Monticello Nuclear Generating Plant

License Amendment Request dated July 27, 1987

Evaluation of Proposed Changes

Exhibit B consists of marked up pages for the Monticello Nuclear Generating Plant Technical Specifications showing the proposed changes as listed below:

Figure 3.5-1 Single Loop Operation Surveillance Power/Flow Curve

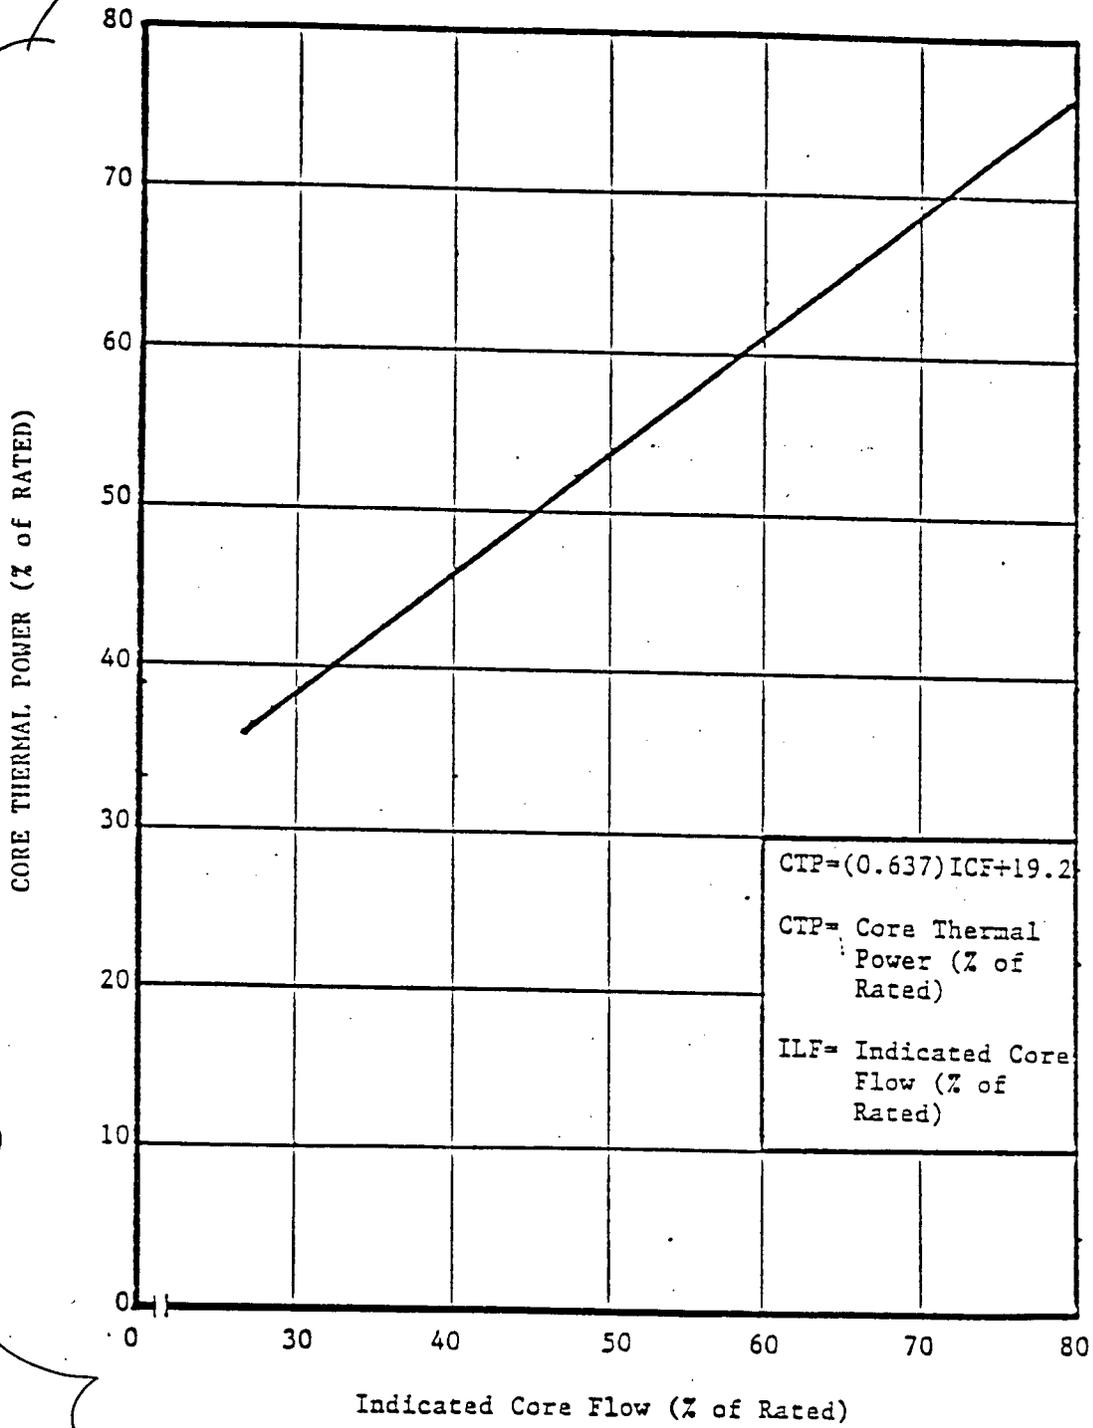
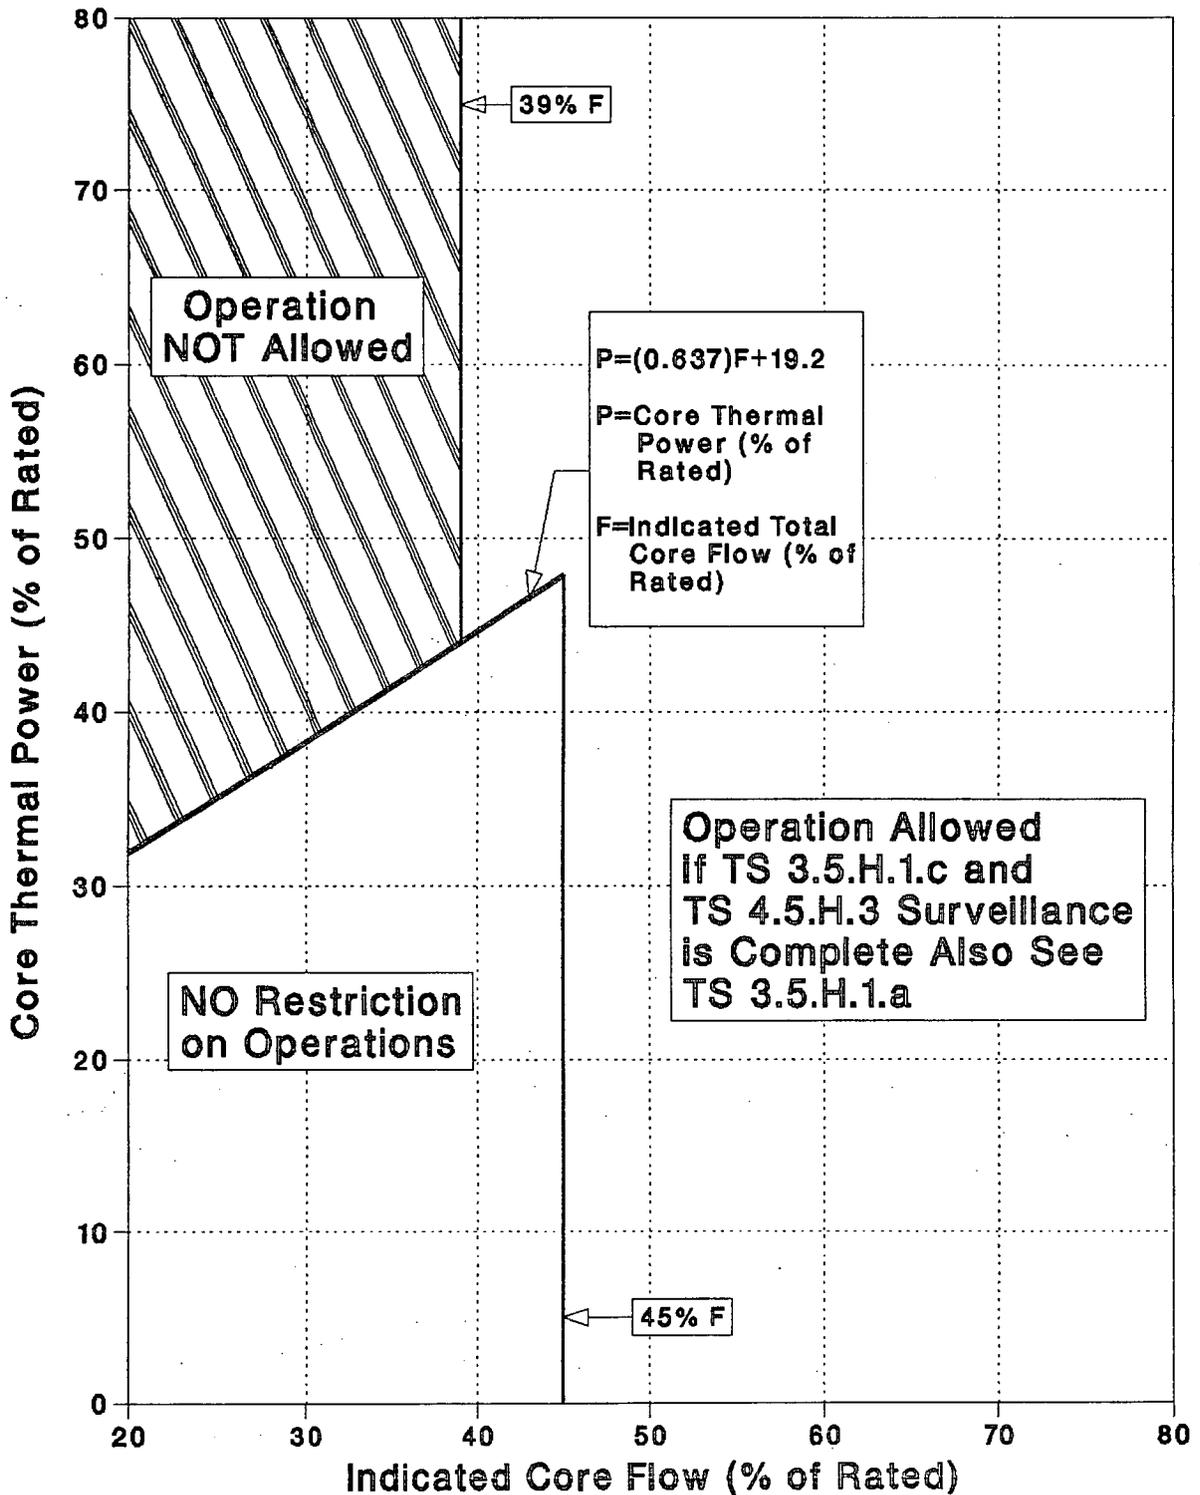
delete and replace with attached
